## Unclassified Airspace using TIBA procedures from ground level to 1500FT AGL

After further consultation and comment from Industry Version 2 of this document holds several suggested changes. The original text remains ~~with strikethrough and shading~~ while replacement text appears with shading.

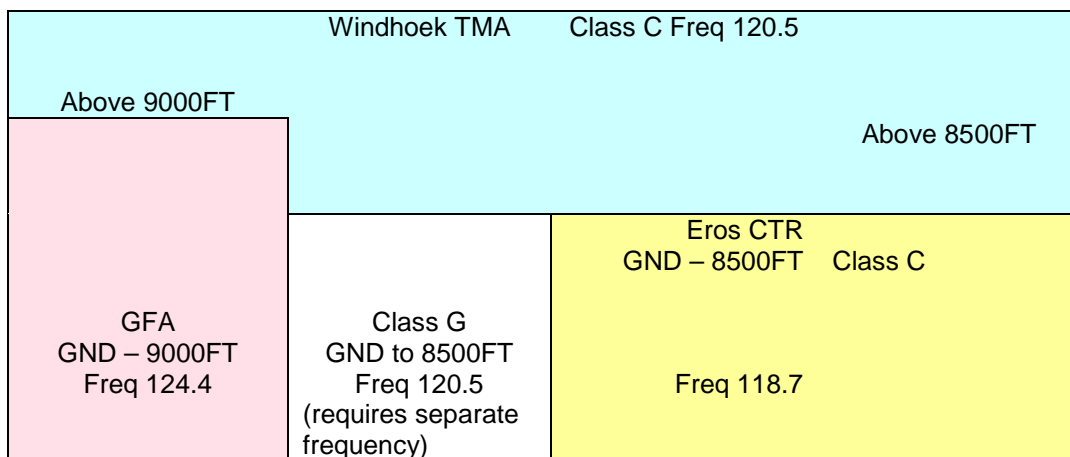
This area has a separate frequency to the adjoining classes of airspace which imposes additional workload on pilots. Further pilots could be transiting this TIBA area and not on the appropriate frequency. It is confusing. The rationale behind this airspace is unclear and no information can be found supporting its existence other than a possible legacy of the South African airspace model used previously.

Recent incidents in the Eros area have been attributed in part to this confusion of broadcast areas.

**Proposal 1:** remove the unclassified TIBA airspace and replace with Class G airspace below all control areas to the ground.

At the same time review the Eros and Windhoek TMA airspace; eg the above diagram indicates possible review to the North of Eros.

*Proposed change to remove Unclassified Airspace*

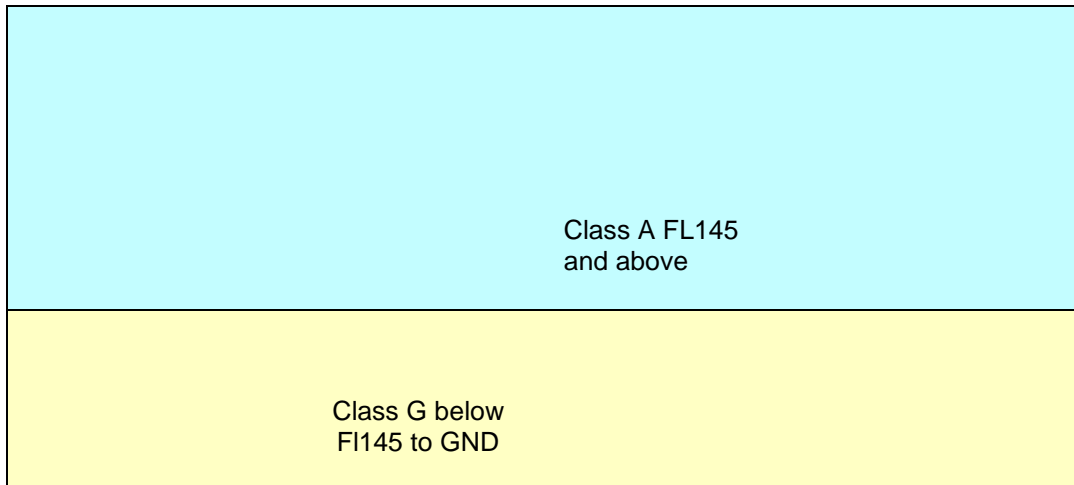
This would also be extended to the Unclassified Airspace across the rest of Namibia; removing the unclassified airspace and replacing with Class G to the ground.

Outside any control zones, Class G would extend from the surface to where it met existing Class C or Class A airspace.
